ALEOS 4.18.1.002_6b9144

RELEASE NOTES

About ALEOS 4.18.1.002_6b9144

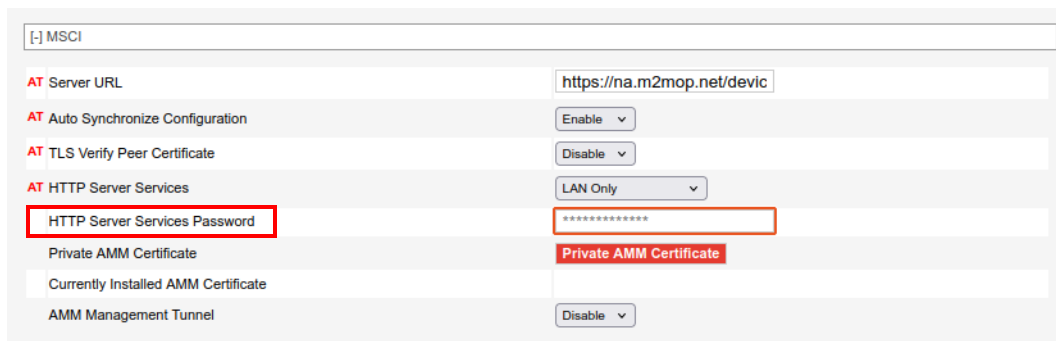
Resolved an issue where the configured MSCI Server password no longer worked after upgrade to ALEOS 4.18.1.

The resolution adds a new ACEmanager setting and AT command to set the MSCI password for server-initiated communication.

To set the password, go to Services > ALMS > MSCI > HTTP Server Services Password or use AT*MSCISERVERPASSWD=<password>.
